CITY PLAN COMMISSION**THURSDAY, MAY 22, 2025****FILE NUMBER:** S245-158**SENIOR PLANNER:** Hema Sharma**LOCATION:** bounded by Altman Drive, Dundee Drive, Merrell Road and Goodyear Drive**DATE FILED:** April 25, 2025**ZONING:** PD 639**PD LINK:** <https://dallascityhall.com/departments/city-attorney/Articles/PDF/Article%20639.pdf>**CITY COUNCIL DISTRICT:** 13**SIZE OF REQUEST:** 11.241-acres**APPLICANT/OWNER:** Cbre Vanir, Dallas Independent School District**REQUEST:** An application to create one 11.241-acre lot from a tract of land in City Block 6461 on property bounded by Altman Drive, Dundee Drive, Merrell Road and Goodyear Drive.**SUBDIVISION HISTORY:** There has been no recent platting activity within close proximity to this request.**STAFF RECOMMENDATION:** The request complies with the requirements of PD 639; therefore, staff recommends approval of the request subject to compliance with the following conditions:**General Conditions:**

**F.P. CALLET
ELEMENTARY SCHOOL
SUBDIVISION**

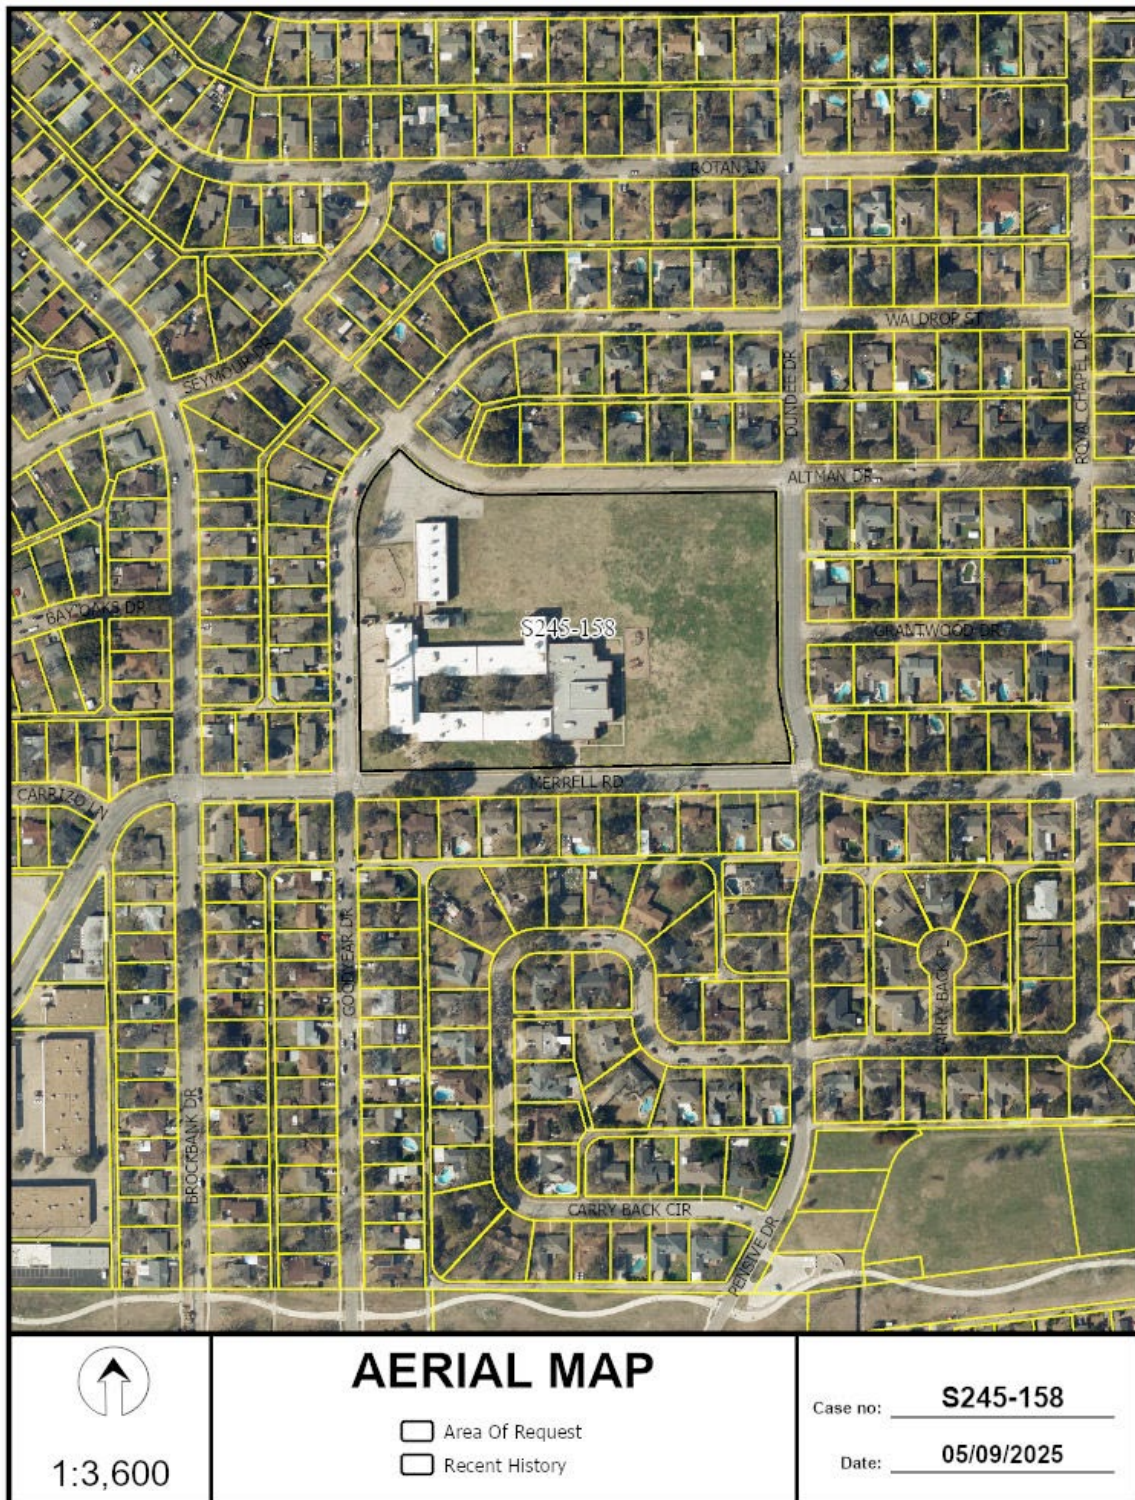
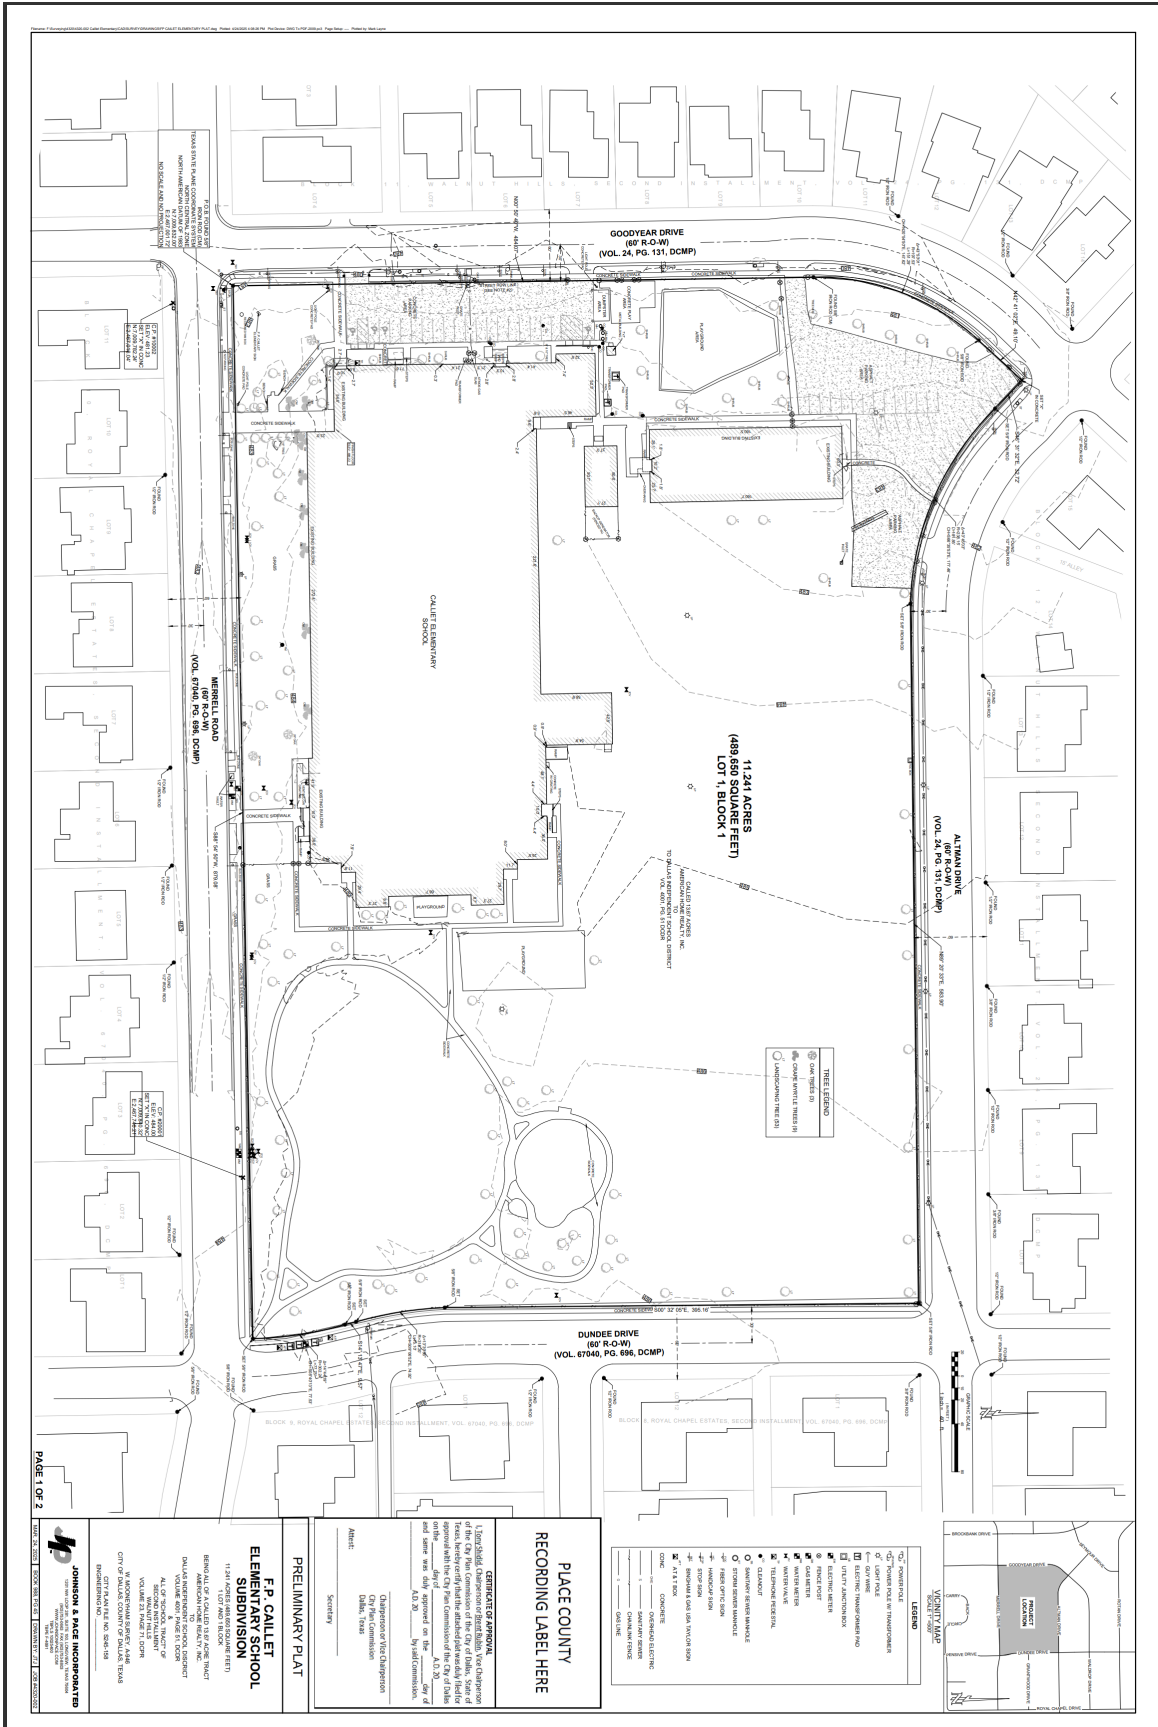
15. On the final plat, dedicate a minimum 5-foot by 5-foot corner clip (via fee simple or street easement) at the intersection of Goodyear Drive & Altman Drive. Section 51A 8.602(d)(1)

16. On the final plat, dedicate a minimum 5-foot by 5-foot corner clip (via fee simple or street easement) at the intersection of Altman Drive & Dundee Drive. Section 51A 8.602(d)(1)

17. On the final plat, dedicate a minimum 5-foot by 5-foot corner clip (via fee simple or street easement) at the intersection of Dundee Drive & Merrell Road. Section 51A 8.602(d)(1)

18. On the final plat, dedicate a minimum 5-foot by 5-foot corner clip (via fee simple or street easement) at the intersection of Merrell Road & Goodyear Drive. Section 51A 8.602(d)(1)

21. Prior to final plat, submit a completed final plat checklist and all supporting documents.
22. On the final plat, show how all adjoining right-of-way was created. Section 51A-8.403(a)(1)(A)(xxii).
23. On the final plat, show Volume 4157, Page 618, Deed Records, Dallas County, Texas.
24. On the final plat, show Volume 67113, Page 908, Deed Records, Dallas County, Texas.
25. Dedicate street easements in fee simple.
26. On the final plat, show Volume 80, Page 1149, Deed Record, Dallas County, Texas.

29. Prior to final plat, compliance with City's street lighting standards including illumination standards, material, installation, and activation per Street Design Manual.
30. Prior to the final plat, remove the fence encroachment located along Altman Drive, Goodyear Drive, and Merrell Road and provide written documentation and pictures to Real Estate division.
31. On the final plat, identify the property as Lot 1 in City Block 35/6461.
